**Written submission from
Northwatch**

**Cameco Corporation,
Blind River Refinery**

**Application to renew licence for Cameco
Corporation's Blind River Refinery**

CAMECO CORPORATION'S REQUEST FOR LICENSE RENEWAL FOR THE BLIND RIVER URANIUM REFINERY

Figure 2: Uranium concentrations in surface soil (0-5 cm) collected in 2000, 2002, 2003, 2007, and 2012 from 12 sampling sites located in the vicinity of BRR

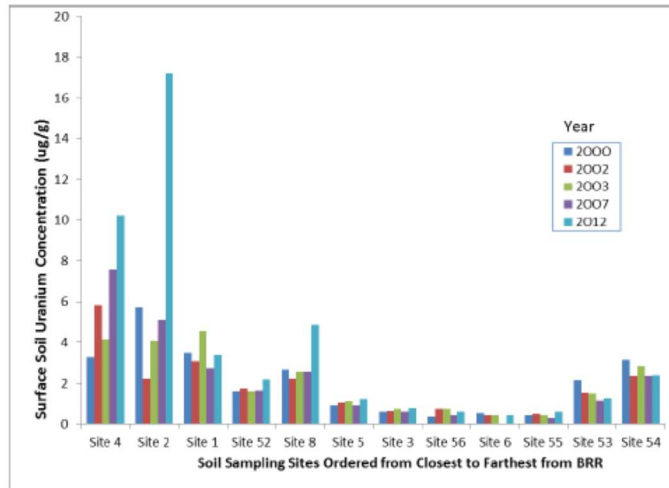
The MOE 2012 report indicated that the highest soil uranium concentrations in 2012 were reported at sites within 500 m of BRR (Sites 4, 2, 1, 52, and 8), consistent with MOE soil uranium data since 2000. As in the Northwatch 2011 report, Sites 2 and 4 results show the highest concentration of uranium, and MOE noted that in 2012 soil uranium concentrations were much higher at Site 2 than in previous years.

While the Ministry of the Environment does not, in their 2012 report, identify that the increased concentrations of uranium in the soil are having a measureable and adverse environmental effect, the sampling results do quite clearly show that the uranium refinery was to that point in time continuing to have a measurable impact in the form of increasing uranium concentrations in a majority of the sampling locations, as depicted in MOE’s Figure 2.
